TITLE: AIR CONDITIONING - PRESSURIZATION CONTROL AND MONITORING - INTRODUCE

OUTFLOW VALVE -8

MODIFICATION No.: 24157K3612

SERVICE BULLETIN No.: A320-21-1083

Location of the Outflow Valve 10HL Figure 1

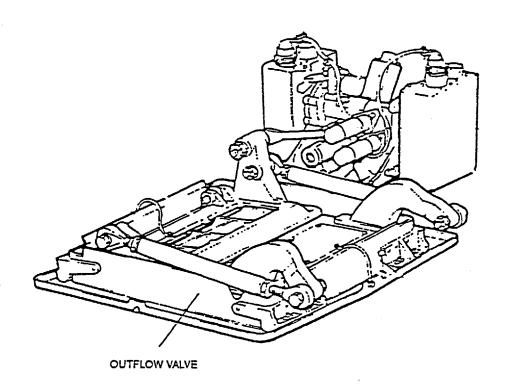
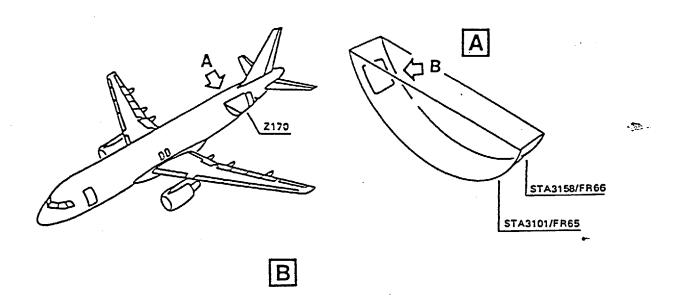
(1) Removal and installation of the outflow valve 10HL

Refer to Figure 1

(a) Replace the outflow valve in accordance with the AMM 21-31-51, P. Block 401 and NORD MICRO Service Bulletin Nos. 15703-21-005 and 16917-21-001.
